UNITED STATES PATENT AND TRADEMARK OFFICE

APPLICATION NO.	FILING DATE	FIRST NAMED INVENTOR	ATTORNEY DOCKET NO.	CONFIRMATION NO.
10/607,975	06/30/2003	Carol L. Erdman	53394.000711	6951
<div>7590 Christopher C. Campbell, Esquire Hunton & Williams 1900 K Street, N.W. Washington, DC 20006-1109</div>			<div>EXAMINER BOGART, MICHAEL G</div>	
			<div>ART UNIT 3761</div>	<div>PAPER NUMBER</div>
			<div>MAIL DATE 10/04/2007</div>	<div>DELIVERY MODE PAPER</div>

Office Action Summary	Application No. 10/607,975	Applicant(s) ERDMAN, CAROL L.	
	Examiner Michael G. Bogart	Art Unit 3761

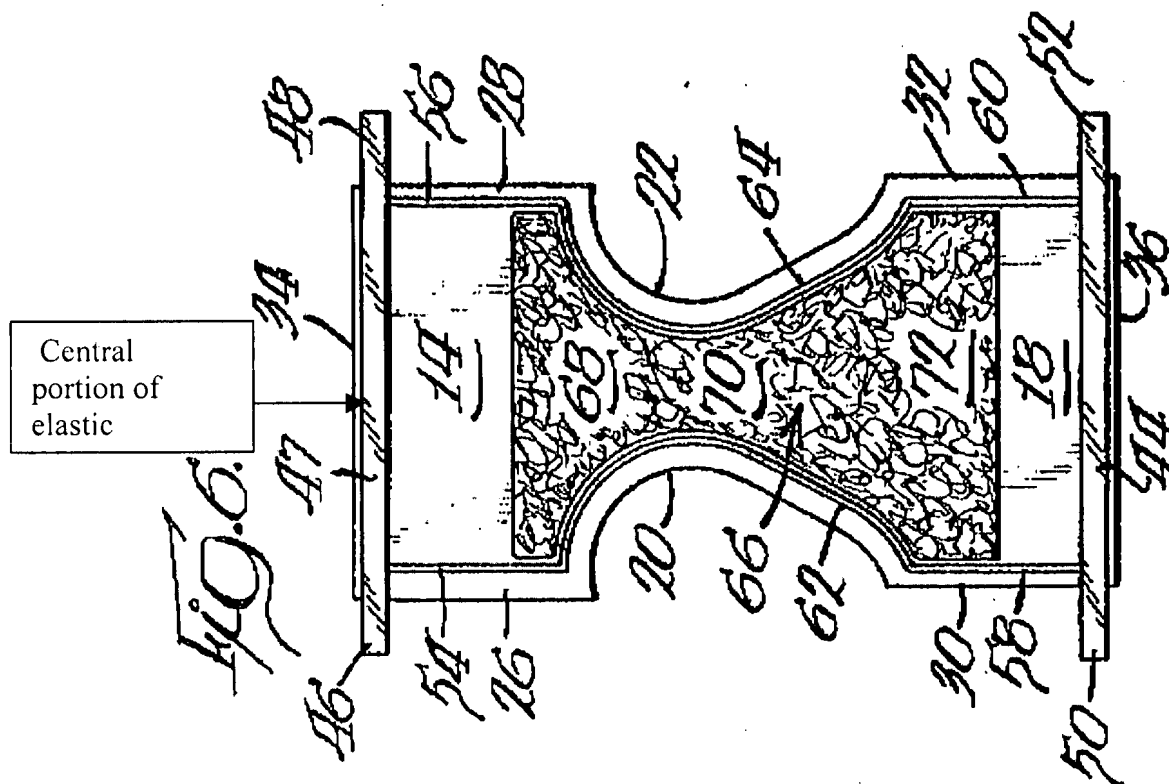
Regarding claim 5, Repke teaches an absorbent article (1) having a front portion (14), a back portion (18), a crotch portion (70) and two side portions (26, 28, 30, 32), the article (1) comprising:

first and second elastic portions (47, 44) operatively associated with the main chassis (14, 16, 18),

the first elastic portion (47) positioned in the front portion (14) of the article (1), the second elastic portion (44) in the back portion (18) of the article (1) and the second elastic portion (44) positioned in the back portion (18) of the article (1),

wherein both the first and second elastic portions (47, 44) have a central portion positioned between the side portions (26, 28, 30, 32) of the article (1) having a lateral width less than a lateral width of the main chassis (14, 16, 18), and

wherein each central portion extends (from edges (34) and (36), respectively) in a longitudinal direction towards the crotch portion (70)(see fig. 6, infra). The central portion is interpreted herein as being the middle third of each elastic strip as measured in the direction that is transverse to the width of the chassis.

Regarding claim 24, Repke teaches that the first and second elastic portions (47, 44) are rectangular in shape (see fig. 6).

Regarding claim 57, Repke teaches a lateral dimension of at least one of the first and second elastic portions (47, 44) perpendicular to the (article's) longitudinal direction is a first distance, a lateral dimension of each of the associated side portions (46, 48, 50, 52) of the first and second elastic portions perpendicular to the longitudinal direction is a second distance, and the first distance is greater than twice the second distance (see fig. 6).

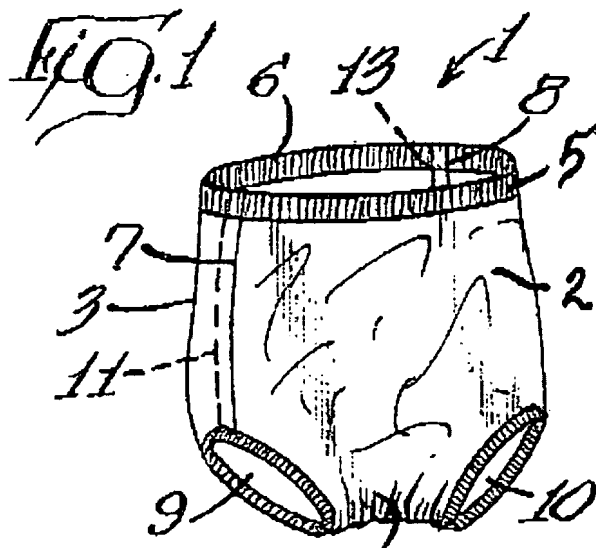
Regarding claims 25 and 26, Repke teaches that the article (1) is a diaper or a pant, see fig. 1, infra).

**FIG. 2A**

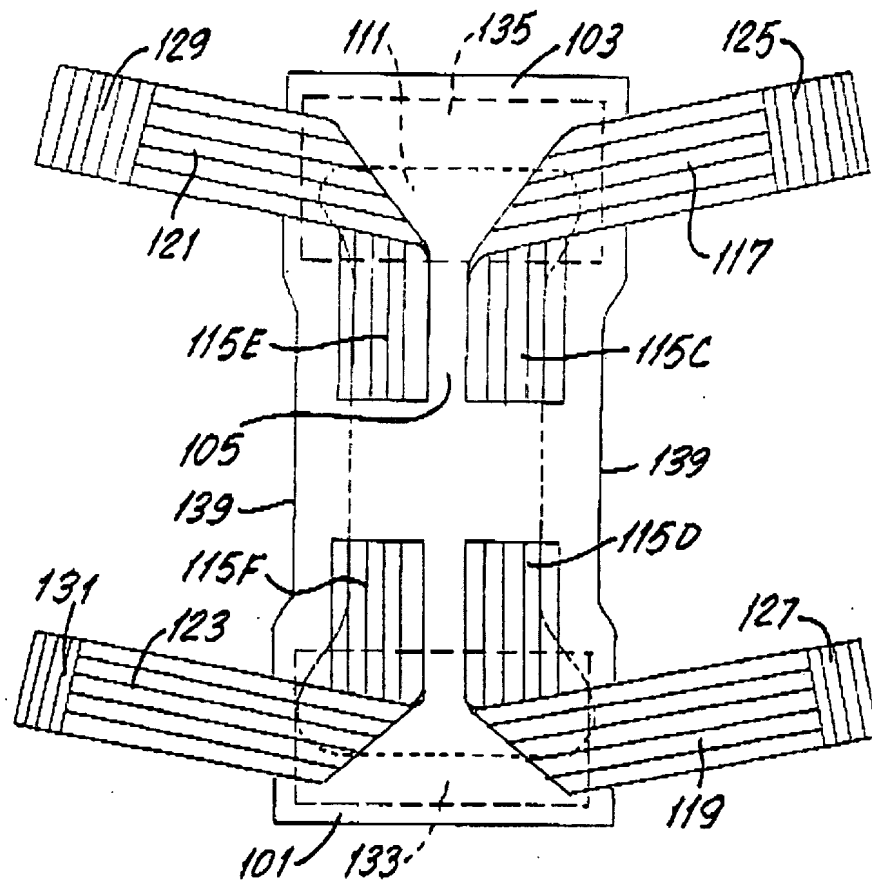
wherein both the first (115C, 117, 115E, 121) and second elastic (115D, 119, 115F, 123) portions have a central portion (115C, 115D, 115E, 115F) positioned between the side portions (139) of the article (100) having a lateral width less than a lateral width of the main chassis (107, 109), and

wherein each central portion (115C, 115D, 115E, 115F) extends in a longitudinal direction towards the crotch portion (105)(see fig. 2A, *infra*). The central portion is interpreted herein as being the middle third of each elastic strip as measured in the direction that is transverse to the width of the chassis.

With respect to claim 12, the first central elastic portion (115C) has a depth that is greater than the depth of the first elastic side portion (117), as shown in figure 2A.

With respect to claim 13, the second central elastic portion (115D), has a depth greater than the depth of the second side portions (119), as shown in figure 2A.

With respect to claim 15, the second central elastic portion (115D) has depth greater than the depth of the second side elastic portions as shown in figure 2A.

With respect to claim 24, the first and second elastic portions can be defined to be rectangular, as shown in figure 2A.

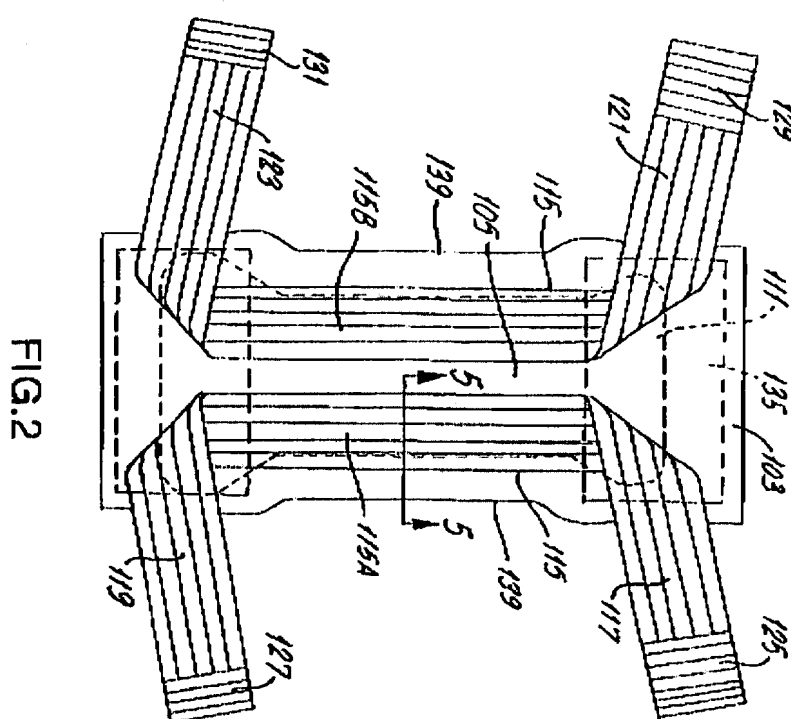
With respect to claim 11, the first elastic portion (115C, 117, 115E, 121) has a first central elastic portion (115C, 115E) corresponds to the front portion (103) of the article (100), and the second central portion (115D, 115F) corresponds to the back portion (101) of the article (100). The article (100) further comprises a first side elastic portions (117, 121) and a second side elastic portions (119, 123).
